EGR TEMPERATURE SENSOR REPLACEMENT AND HARNESS ROUTING

Prevost vehicles

Special Bulletin

SP15-322A

Figure 1 Location on engine.

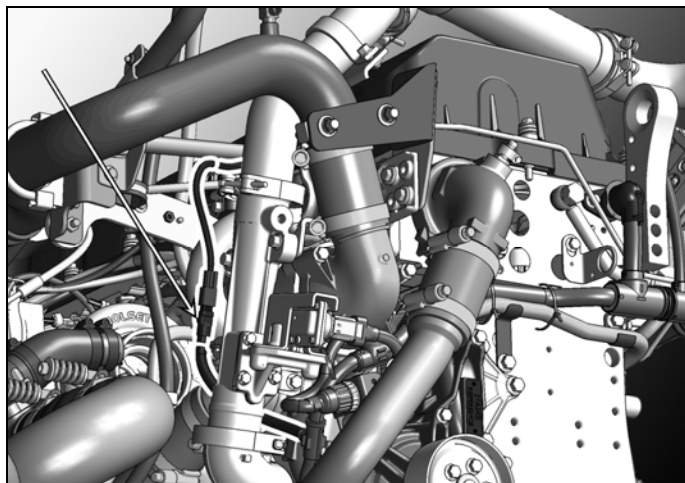
- 1) On the engine, road side, locate this branch of the engine harness.

Figure 3

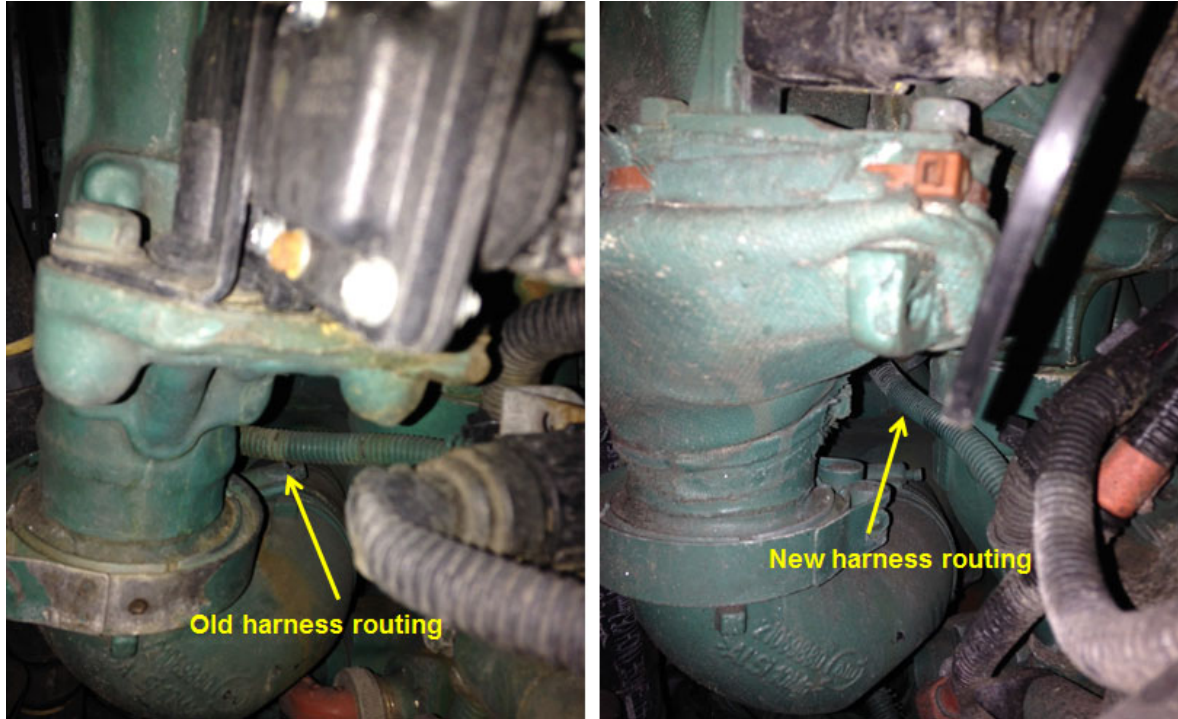
- 3) Disconnect engine harness lead from EGR temperature sensor and pull down to allow re-routing.
- 4) Reroute it back up through the inboard side of the lower coolant transfer pipe and EGR cooler Exhaust outlet pipe.

Figure 4

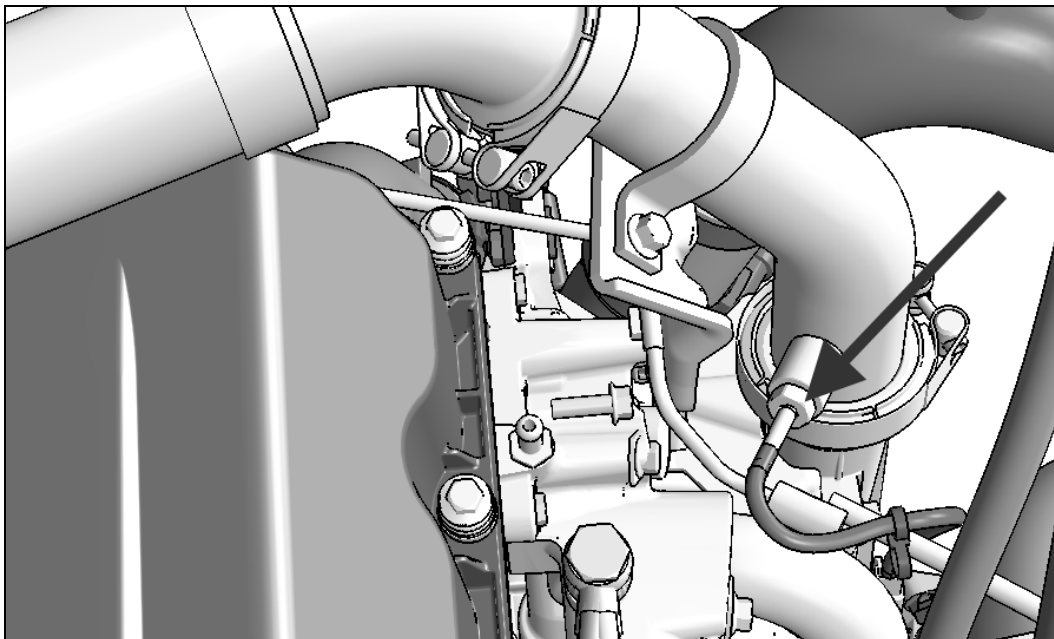
- 5) Replace the EGR temperature sensor with a new #21164790 (Tighten to 33 lbf-ft) then connect to harness

Figure 5

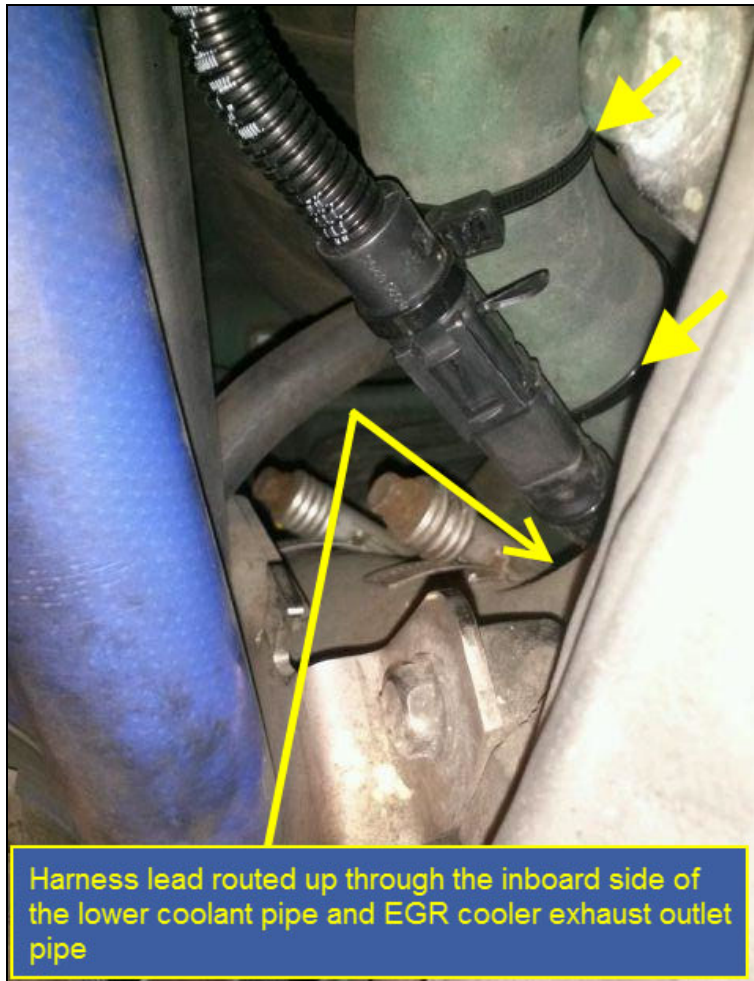
- 6) Secure to the EGR cooler coolant return pipe with supplied cable ties # 507664 (Fig. 2; 3)
